SUBJECT: Forwards response to RAI re cycle 6 steam generator
 evaluation rept.

**Subject: Palo Verde Nuclear Generating Station (PVNGS)
Unit 3
Docket No. STN 50- 530
Response to Request for Additional Information
Regarding the Unit 3 Cycle 6 Steam Generator
Evaluation Report**

**APS Response to USNRC Request For Additional Information
Related to Palo Verde Unit 3 Steam Generator Evaluation
Report**

Figure 3

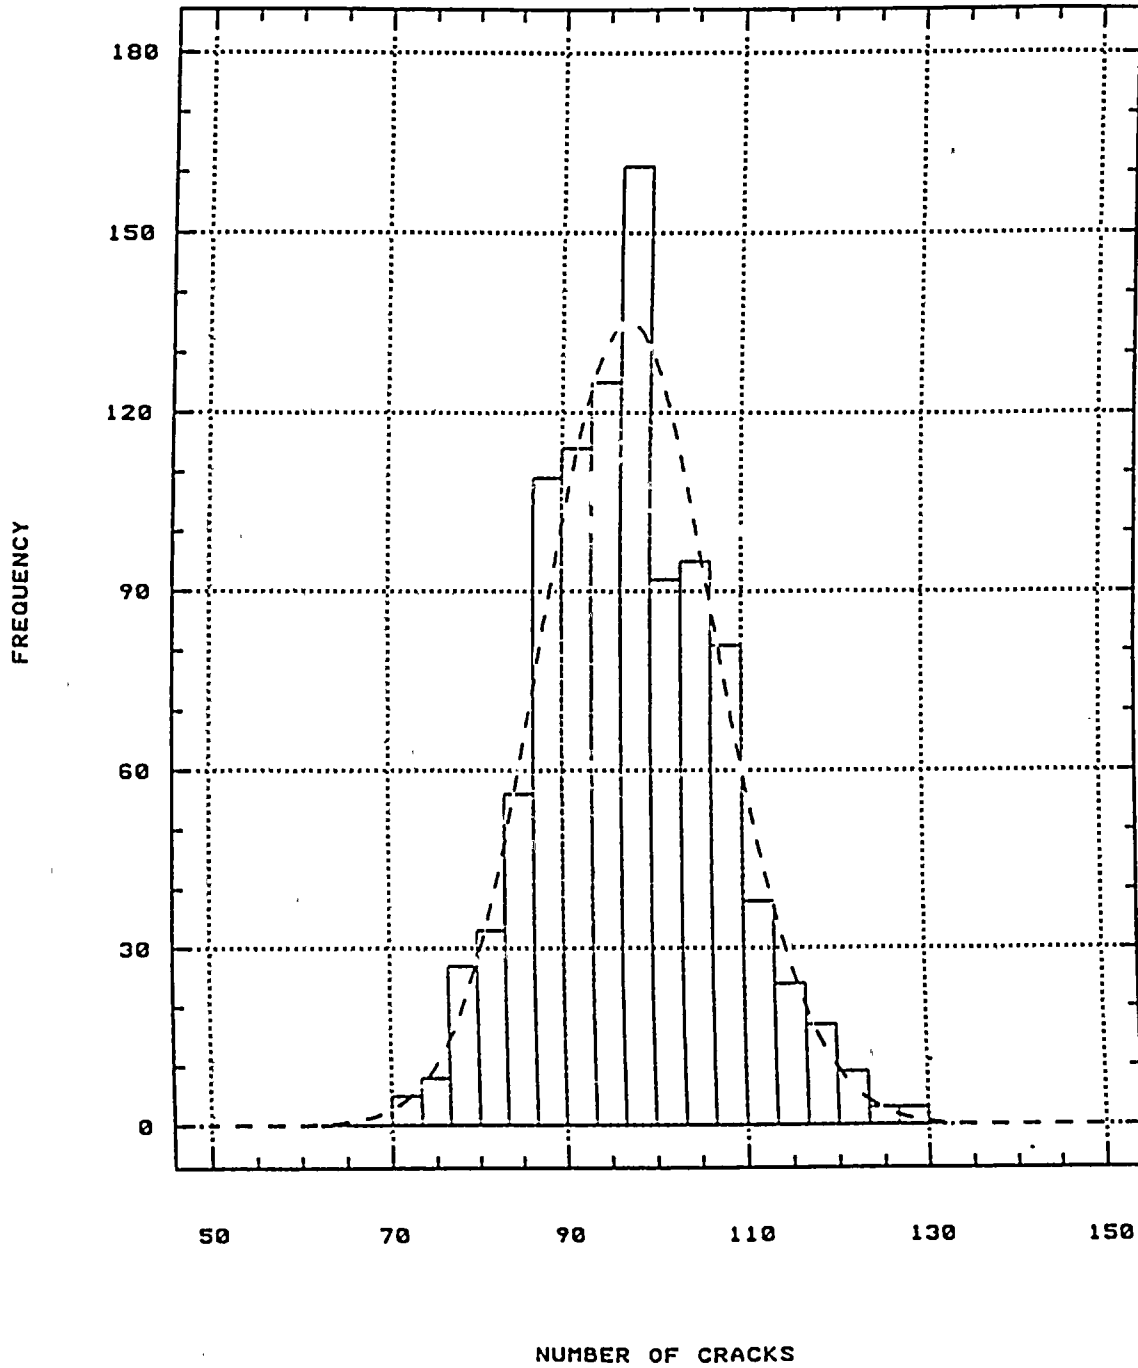
The RAI discusses Figure 4.3 from Reference 1. Two questions have been raised by the USNRC Staff. The first question regards the differences in the histogram when compared to Figure 3. The Staff also questioned the apparent under-prediction of the 50% probability value. For

Figure 4.3 Predicted Number of Defects, U3R5

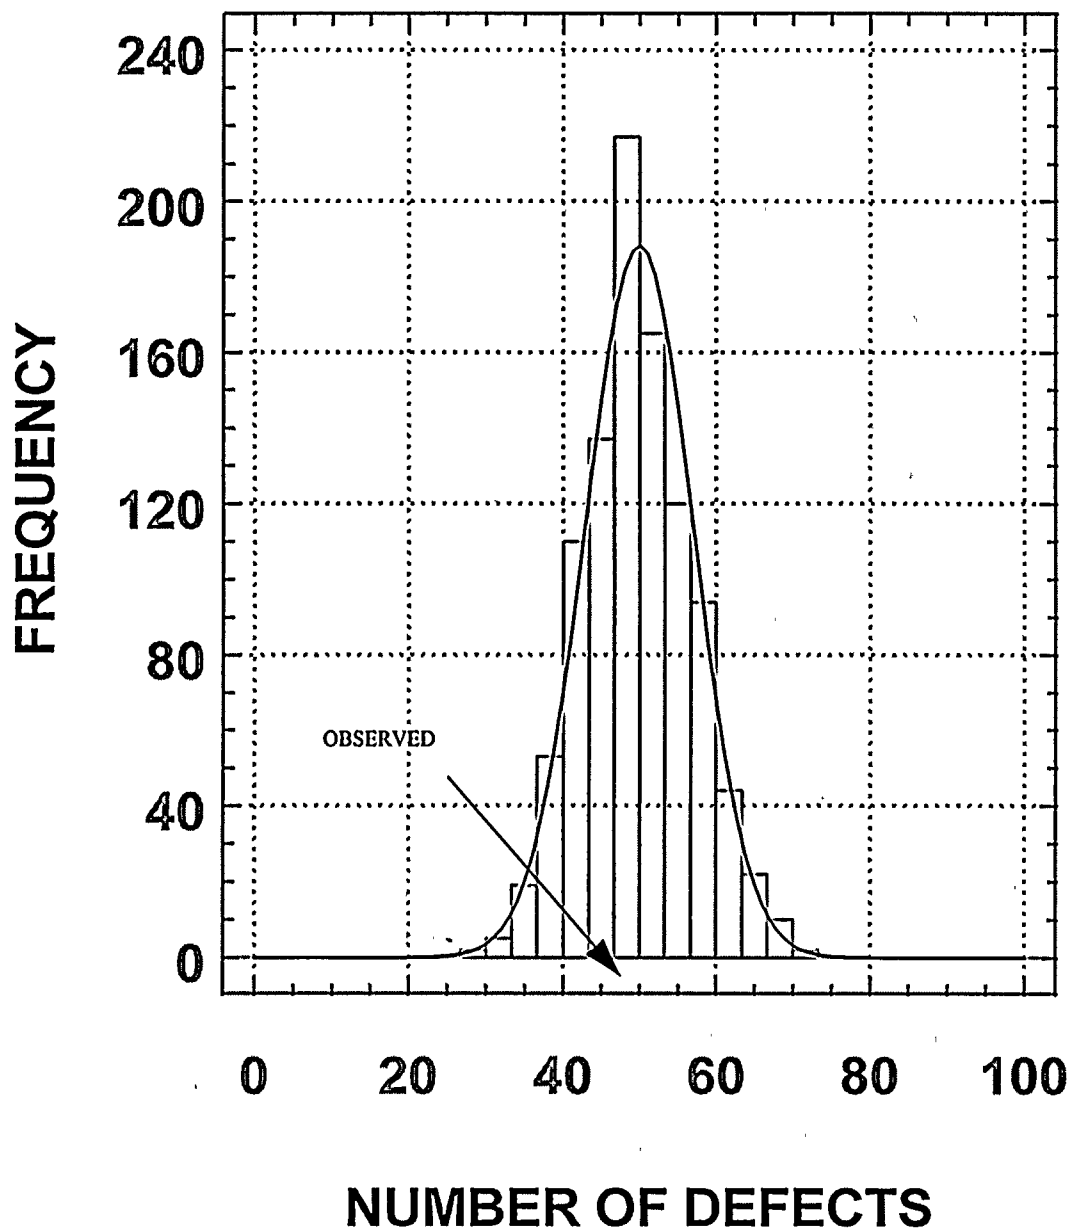
With respect to the comparisons between actual and projected values: (1) any discrepancies should be discussed [e.g., from Figure 4.3, the expected number of indications appeared to be under predicted by the methodology (i.e., the actual number of indications appear to exceed the 50 percent probability value for the expected number of indications)]; (2) differences between previous submittal' results should be addressed (i.e., Figure 4.3 does not match a similar figure provided in the January 5, 1996 letter); and (3) the frequency axes of these figures should be clarified.

clarification purposes, Figure 4.3 is the result of benchmarking the Cycle 6 simulation model, and by definition, could not be used in a Cycle 5 condition monitoring assessment. As stated previously, the APS simulation model is a multiple cycle model, and therefore benchmarking is a critical part of simulation resolution and validation.

In developing a response to the RAI, APS has discovered that when the Figure 4.3 graphic was inserted into the Reference 1 report computer file, the "observed" arrow shifted to the right due to a software error. Please note that the arrow is only an annotation, and not part of the modeling process. As such, the histogram was not affected. As stated previously, the actual number of defects for U3R5 was reported as 48 defects not the 60 value shown in the original Figure 4.3. Figure 4.3, as well as Figures 4.1 and 4.2 of Reference 1, have been corrected and included in this package. The histograms demonstrated the validity of the benchmark. Overall, the model benchmarks were expected to improve over the pre-inspection projections based on the larger data set of paired Unit 3 RPC voltage data. Additionally, model optimization and better knowledge of the effect of the improved Plus Point probability of detection (POD) contributed to goodness of fit. Based on this assessment, APS concludes that the analysis methodology has provided consistent and conservative simulation of the corrosion rates and inspection and repair processes in the PVNGS steam generators.

The RAI also requested that the frequency axes of these histograms be clarified. As stated on page 20 of Appendix A in Reference 1, for calculation of probability of tube burst and the development of a distribution function for Regulatory Guide 1.121 structural exceedances, the simulation of the entire process (Figure 5) is performed 10,000 times. For benchmarking purposes, a shorter run of 1000 simulations of expected past outcomes is performed. The axis is therefore, the frequency of computer generated outcomes based on the 1000 benchmarking simulations.
